Clinch River Nuclear Site  
NRC Docket No. 52-047

**Subject: Response to Request for Supplemental Information Regarding Changes Made in Revision 2 of the Application for Early Site Permit for Clinch River Nuclear Site**

### Supplemental Information Regarding the Small Landslide Discussed in the March 1, 2019 Public Meeting Regarding TVA's Early Site Permit Application

Figure 1

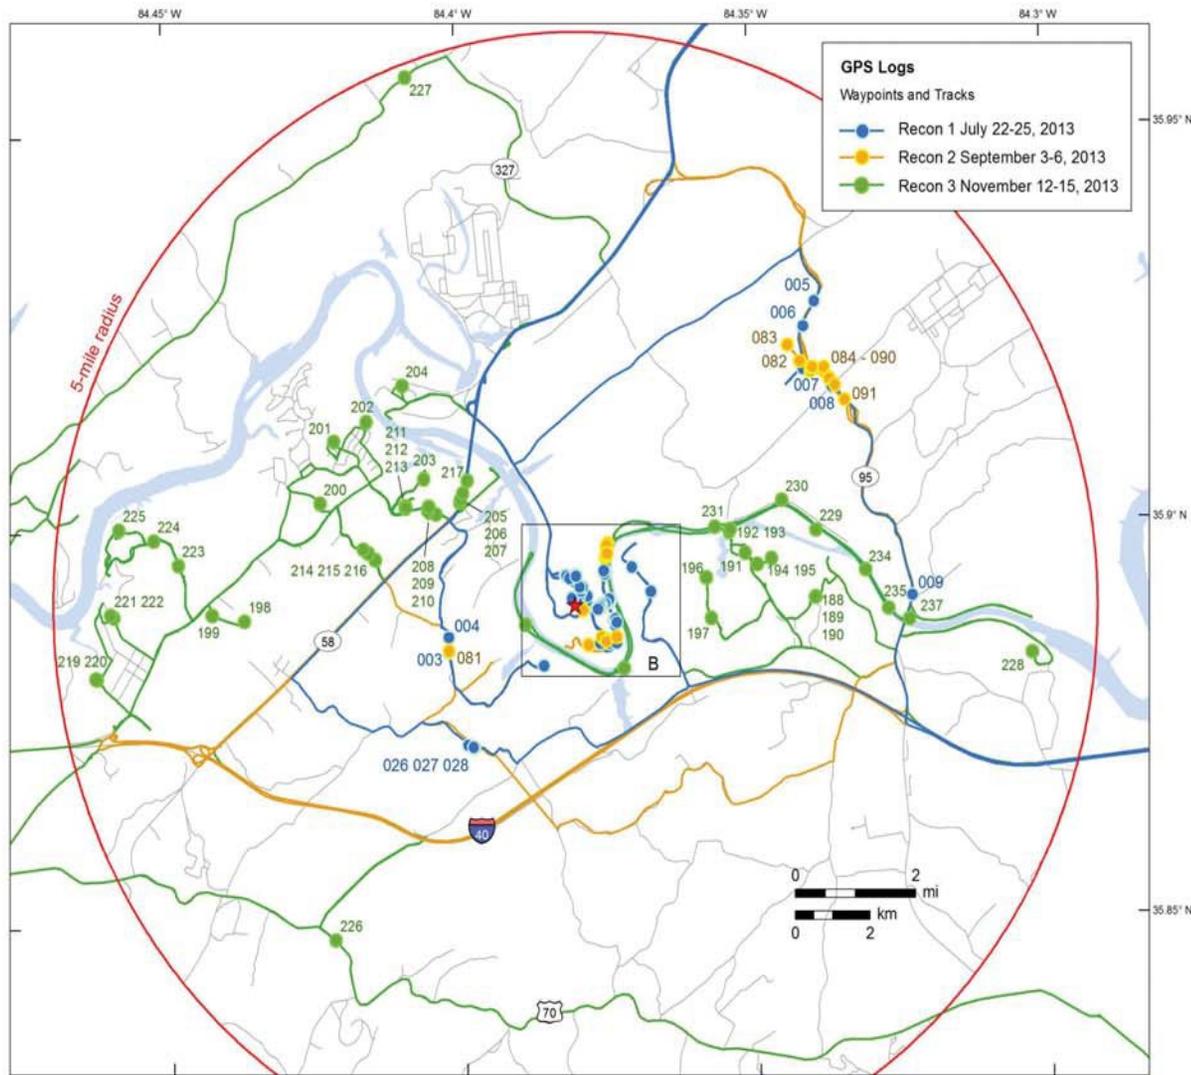
1. *Describe the location of the small landslide.* The landslide is located along the northeastern edge of the site peninsula. Figure 1 of this enclosure provides a map with the location of WP-077 (location of the small landslide) on the CRN Site taken from the Geologic Field Reconnaissance Report.
